HERON LANDING SUBDIVISION

APPLICATION NUMBER 22 DATE January 17, 2008

REQUEST Subdivision

DETAIL SITE PLAN

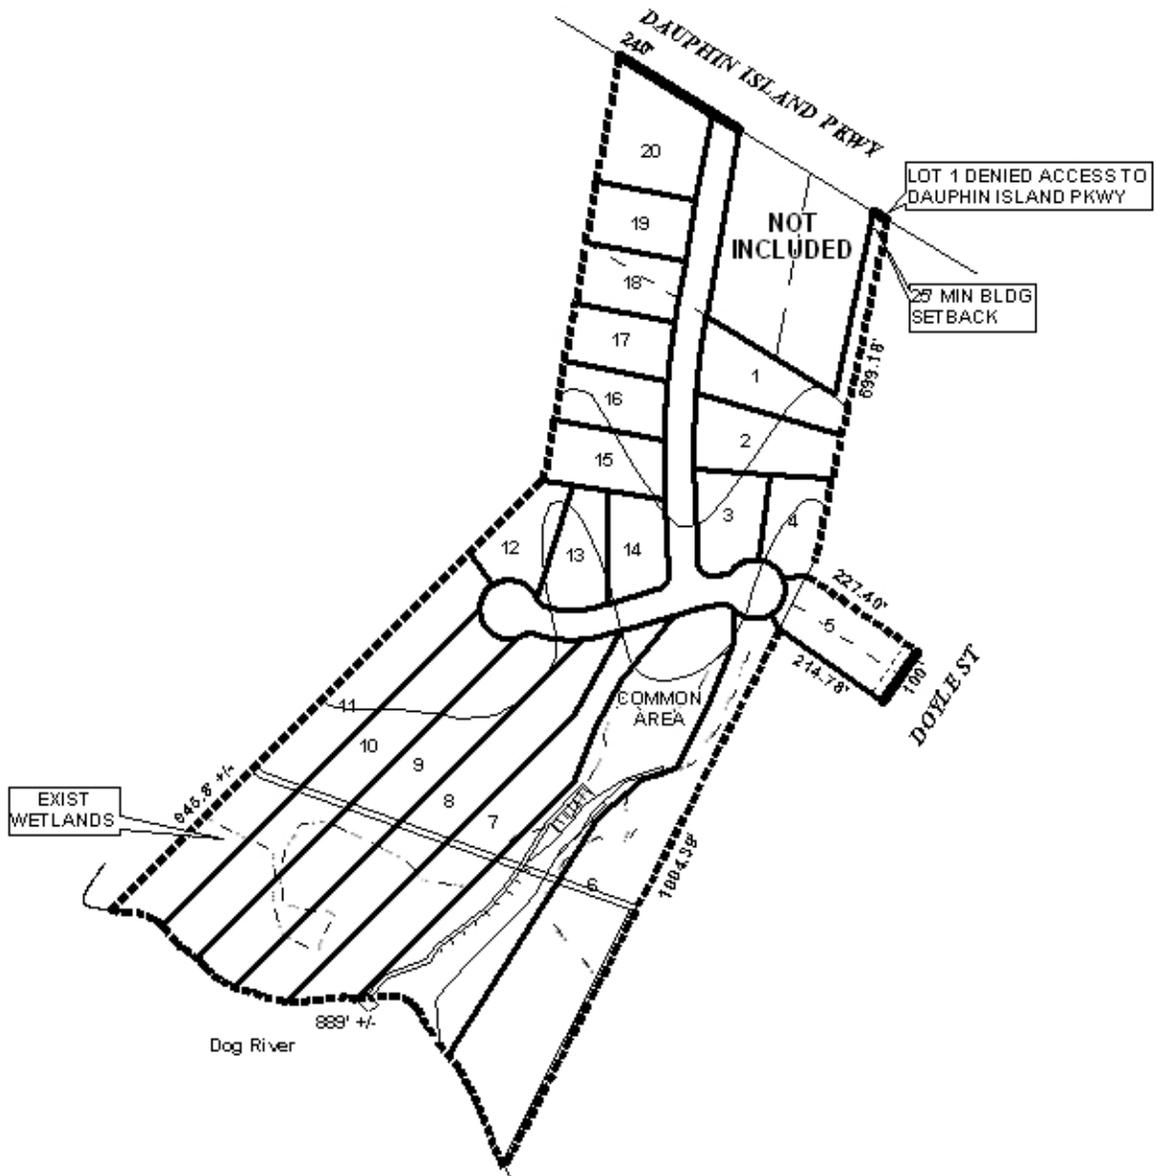
The plat currently under consideration does not reflect many of these conditions of approval.

The site fronts on Dauphin Island Parkway, a major street with adequate right-of-way, and has a portion of the site abutting Doyle Street, a minor street lacking curb and gutter. The existing right-of-way for Doyle Street where the site abuts it is 50-feet, which is not adequate due to the street lacking curb and gutter. Since Doyle Street dead-ends at Dog River, and due to the limited number of homes served by the street, it is recommended that the minimum building setback from Doyle Street for the site in question be increased to provide 55 feet, as measured from the centerline of Doyle Street. Access to Doyle Street from Lot 5 should be denied, as indicated on the plat.

The proposed Lot 1 has frontage on both the proposed residential street and Dauphin Island Parkway. The frontage on Dauphin Island Parkway is only 25-feet, and no justification is provided for the 25 by 320 foot long strip to be part of the proposed Lot 1, however, the adjacent property is under separate ownership, thus it cannot be required to be a part of the current application.

Due to the limited frontage of all proposed lots, each lot should be limited to one curb-cut, with the size, design and location to be approved by Traffic Engineering and in conformance with AASHTO standards. Proposed Lot 1 should be denied direct access to Dauphin Island Parkway, as depicted by the note on the preliminary plat. Proposed Lot 20 should be denied direct access onto Dauphin Island Parkway if it is to be used residentially (and appropriately rezoned), otherwise its one curb-cut may be to Dauphin Island Parkway, subject to approval by Traffic Engineering and ALDOT.

It appears that the cul-de-sac design, as proposed, does not comply with the 2003 International Fire Code, as adopted by the City of Mobile. The road layout should be redesigned to ensure compliance: the cul-de-sac diameter should be revised to provide a 120-foot diameter right-of-way.

The 25-foot minimum building setback line from the right-of-way edge is not depicted for all proposed lots (with the exception of Lot 5), and will be required (from the right-of-way setback) on the final plat.

Proposed Lots 6 – 11 do not comply with the recommended depth to width ratio in Section V.D.3. of the Subdivision Regulations. Due to the proximity to Dog River and the potential presence of wetlands, a waiver of Section V.D.3. may be appropriate.

It should also be noted that the final plats for the subdivisions approved in 2002 depicted drainage easements and sanitary sewer easements that may not be depicted on the current application's preliminary plat. The plat should be revised to show all easements that occur on the site, as they may affect the applicant's ability to develop the site. It should also be pointed out that research provided by an abutting property owner clearly shows that there is a public drainage easement crossing the site from Dauphin Island Parkway to Dog River: the drainage easement has not been maintained, thus flooding and ponding on the site is affecting neighboring properties.

- 3) Depiction and labeling of FEMA flood zones and required finished floor elevation information on the final plat;
- 4) Revision of the plat to include the phrase “future development” across all lots not proposed for inclusion in first phase of the subdivision;

- 5) Placement of a note on the final plat stating that proposed lots 18-20 shall not be recorded until the zoning issues for lots 18 and 19 are resolved;

- 6) Placement of a note on the plat stating that lot 5 is denied access to Doyle Street, and that lot 1 is denied direct access to Dauphin Island Parkway;

- 7) Placement of a note on the plat stating that all Lots 1-19 are limited to one curb-cut, with the size, design and location to be approved by Traffic Engineering and in conformance with AASHTO standards, and that Lot 20 is limited to one curb-cut, with the size, design and location to be approved by Traffic Engineering and ALDOT, and conform to AASHTO

standards, however, if lot 20 is rezoned to a residential designation, it shall be denied direct access to Dauphin Island Parkway;

- 8) Placement of a note on the final plat stating that the design and location of the proposed road intersection with Dauphin Island Parkway be approved by Traffic Engineering and ALDOT, and conform to AASHTO standards;

- 9) Revision of the plat to depict a 55-foot setback line, as measured from the centerline of Doyle Street, for lot 5, and revision of the plat to depict the 25-foot minimum building setback line from the right-of-way for all other lots;

- 12) The labeling of the lots with their size in square feet, or placement of the same information in a table on the final plat; and
- 13) Full compliance with all other municipal codes and ordinances.
